Talking points

- View loss via the 4 Tenacity steps (“Moderate” of “Devastating”)
- Is this “Skilled Design”?
- Clause 6.9
- The cumulative effects of the TOD rezoning? Two 95m towers to the east.
- Is the RtS sufficient?
- Image from P10, Appendix U - Visual Impact Assessment Part 1:
<https://majorprojects.planningportal.nsw.gov.au/prweb/PRRestService/mp/01/getContent?AttachRef=EXH-62637965%2120240722T072821.435%20GMT>
- Camera location 3

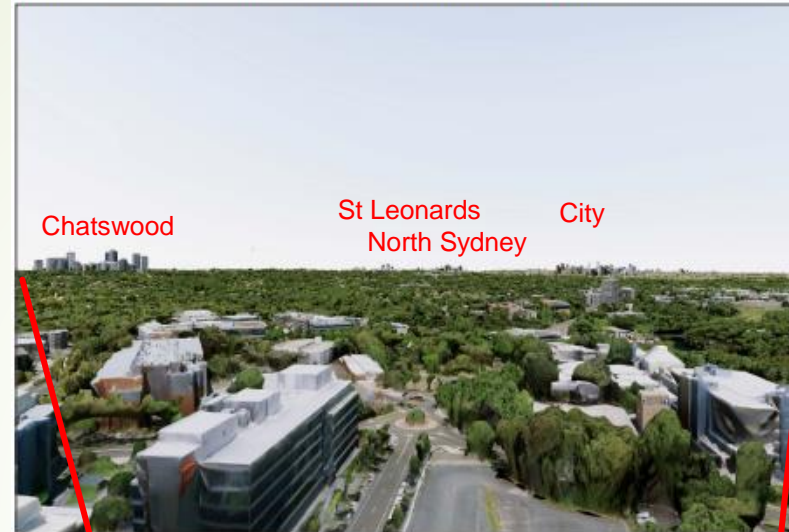
Tenacity Step 2: What part of the property are the views obtained.

- All unit have one a single Easterly outlook
- 10 Floors of Ryde Garden will lose their horizon view
- Residents are:
 - First home buyers
 - Young families
 - Empty nest downsizers
 - Renters
 - Many nationalities

5.2 CAMERA POSITION 02 - RYDE GARDENS, 1 NETWORK PLACE, RL121.0

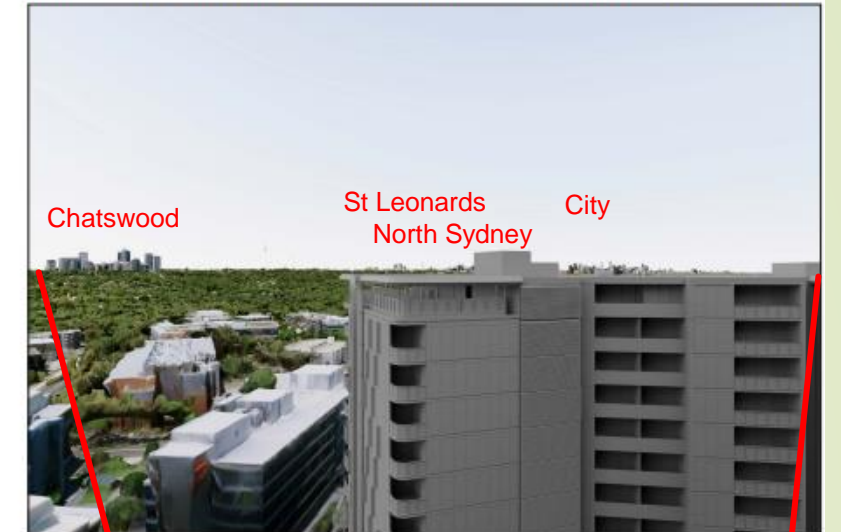
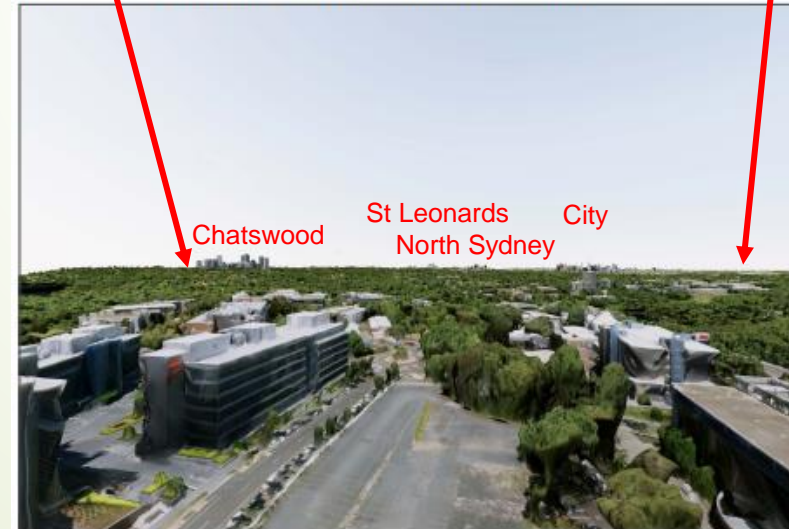
Tenacity Step 3 – the extent of the impact!

- View loss “Moderate” or “Devastating”.
- Views from Camera 3 are with a much wider-angle lens, minimizing the view loss.
- **View loss is ALMOST TOTAL!**
- Images from P7&9, Appendix U - Visual Impact Assessment Part 1:
<https://majorprojects.planningportal.nsw.gov.au/prweb/PRR estService/mp/011/getContent?AttachRef=EXH-62637965%2120240722T072821.435%20GMT>

Tenacity Step 4 – the reasonableness of the proposal

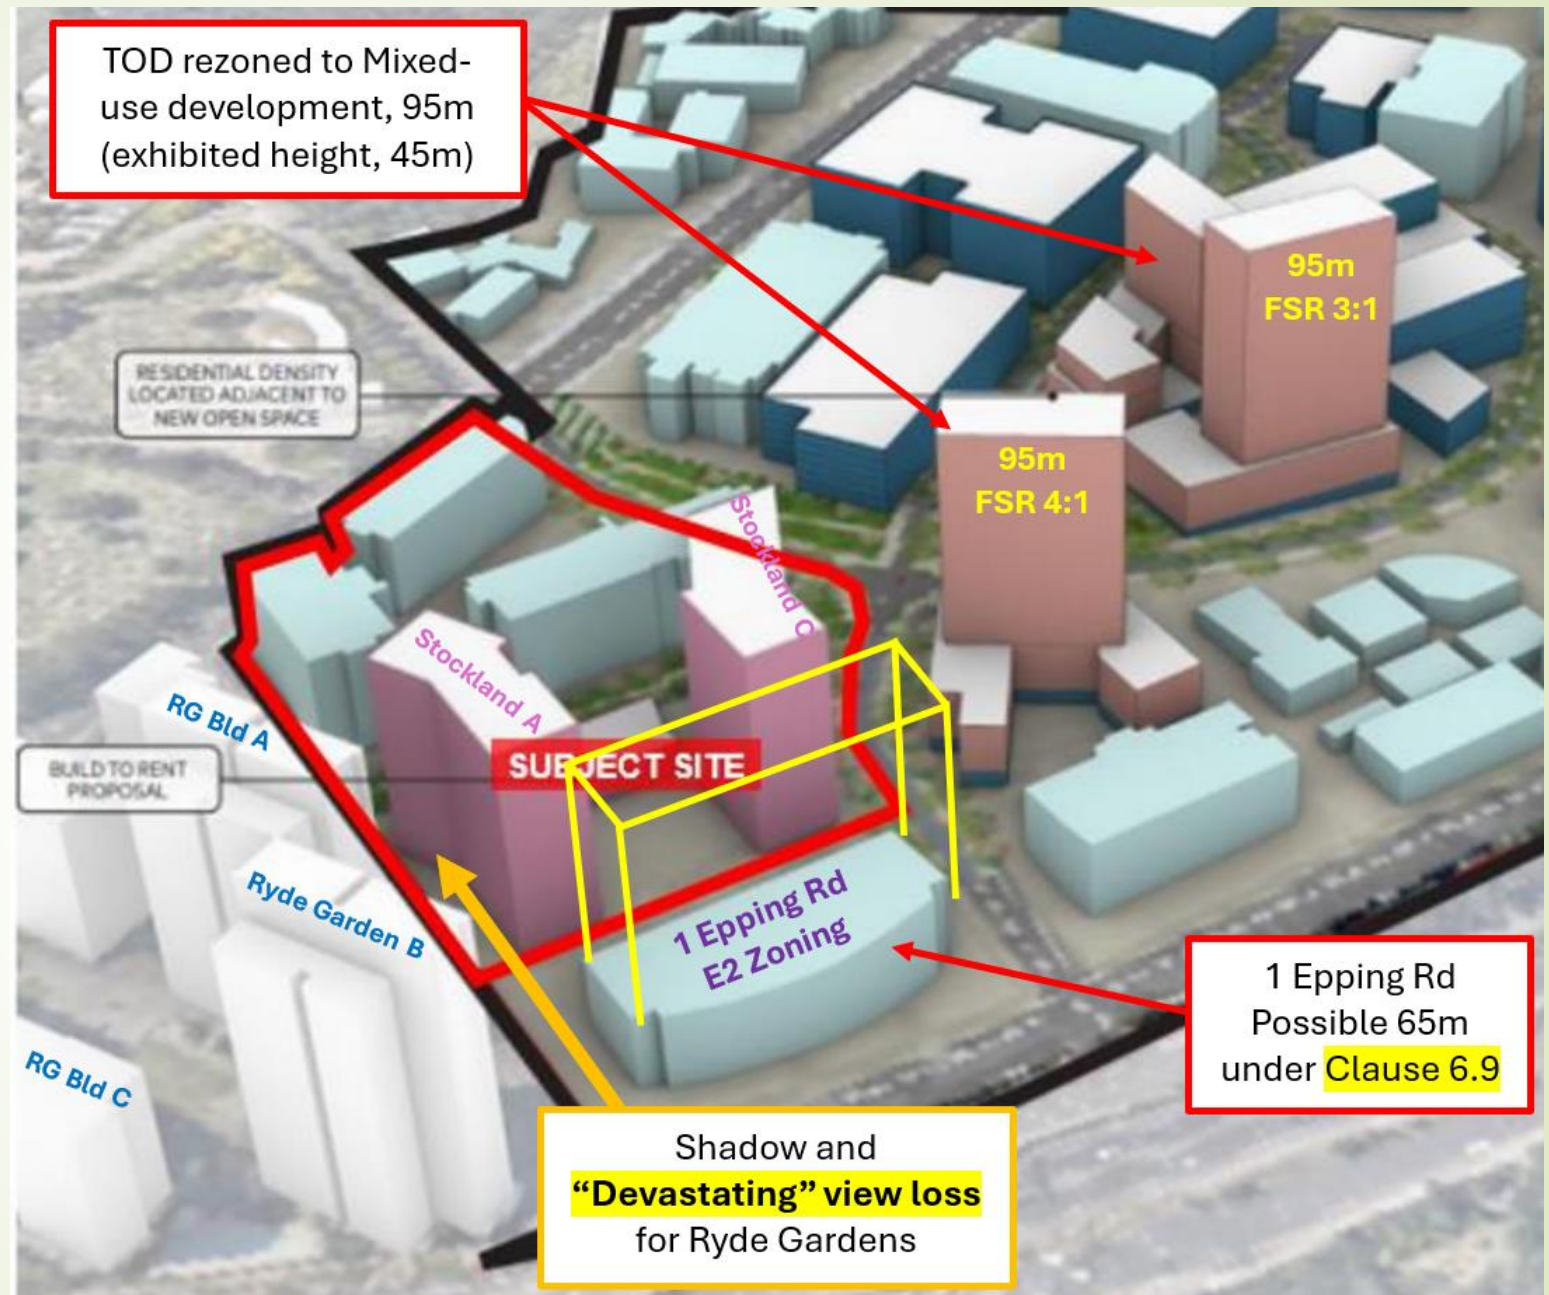
- A development **compliant with all planning controls** would be considered more reasonable.
 - Compliance relies on Clause 6.9 and **transfer of GFA & parking from Trinity Stage I**
- View loss **“Devastating”, not “Moderate”**.
- **“Skilled Design” would not extend from corner to corner**
- The RfS purports that Building A is **“a mid-distance townscape element”!** (P5, RfS)
<https://majorprojects.planningportal.nsw.gov.au/prweb/PRRestService/mp/01/getContent?AttachRef=EXH-62637965%2120240722T072824.566%20GMT>
- The diagram is from P26 of the DPHI Assessment Report:
<https://majorprojects.planningportal.nsw.gov.au/prweb/PRRestService/mp/01/getContent?AttachRef=SSD-55844212%2120250522T030612.064%20GMT>

1 Epping Rd (Old Microsoft Building)

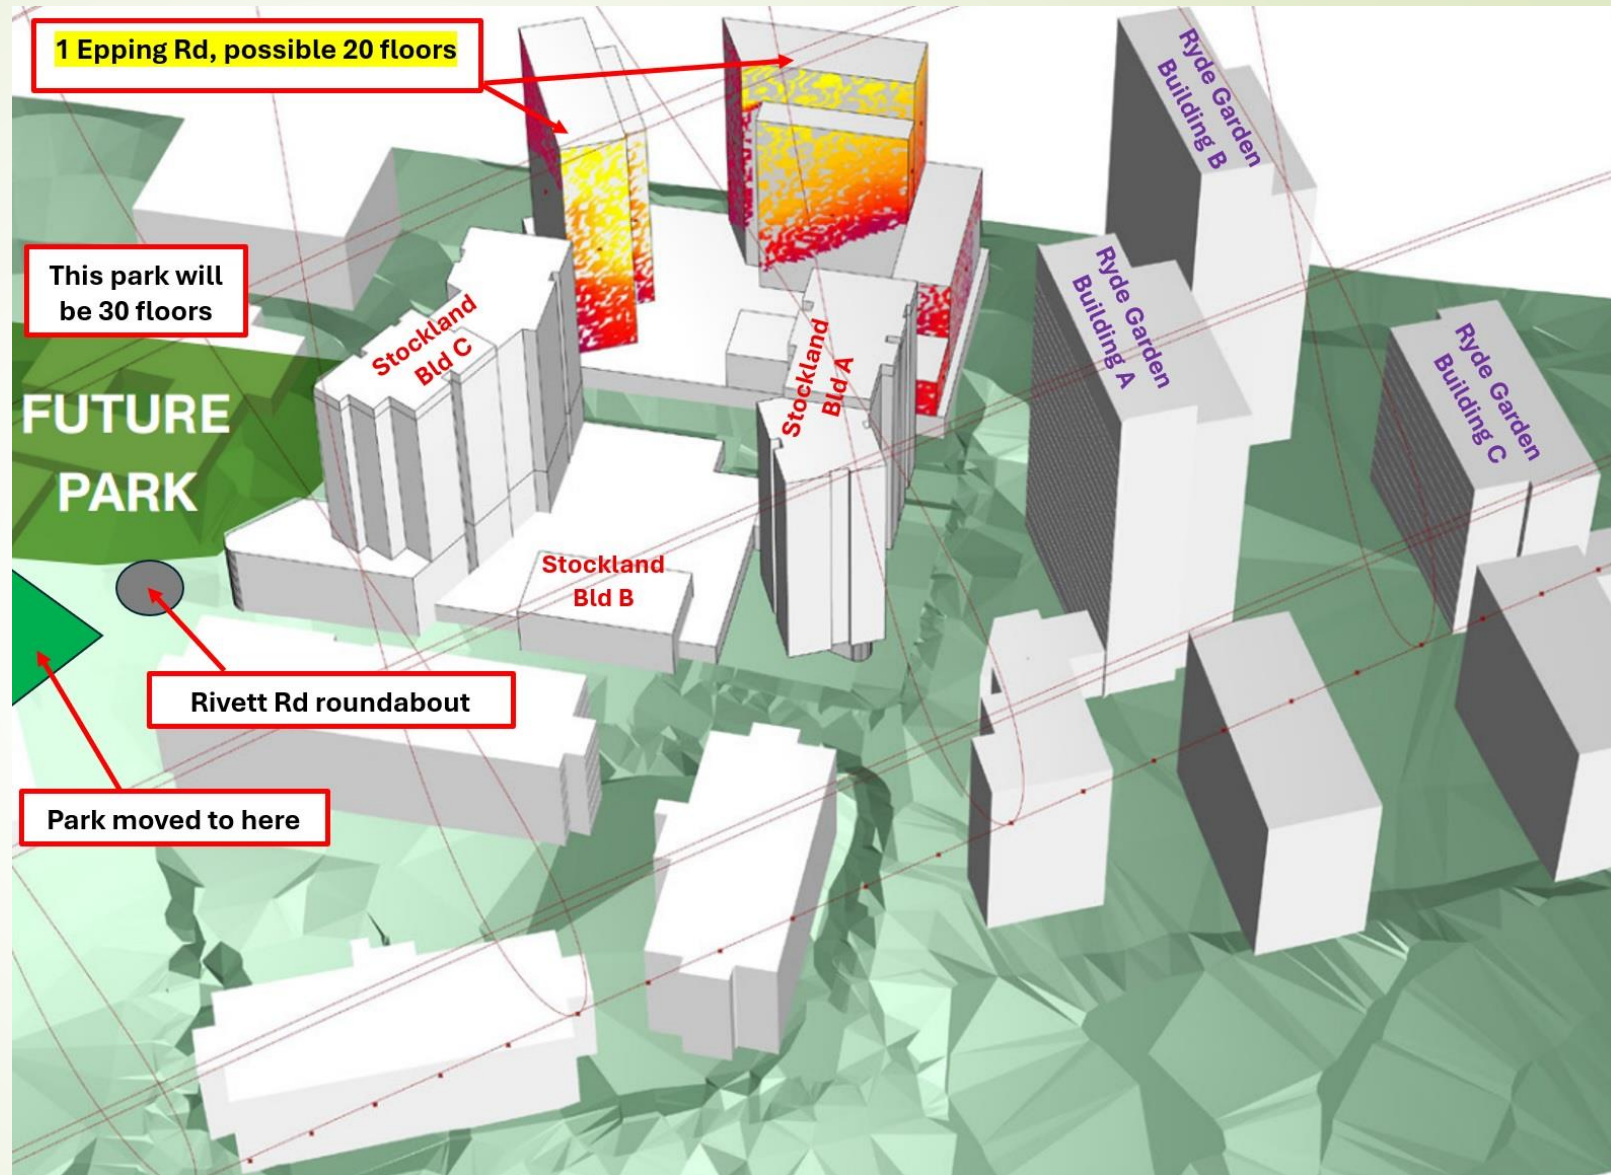
- If Stockland is deemed to satisfy Clause 6.9, **Goodman (1 Epping Rd) appears ready to rise to the same height.**
- Planning appears not to have considered the **TOD park location change.**
- Image from P19, Response to Submissions Design Report (Appendix F - Architectural Design Report Part 1):
<https://majorprojects.planningportal.nsw.gov.au/prweb/PRRestService/mp/01/getContent?AttachRef=EXH-62637965%2120240722T072833.031%20GMT>
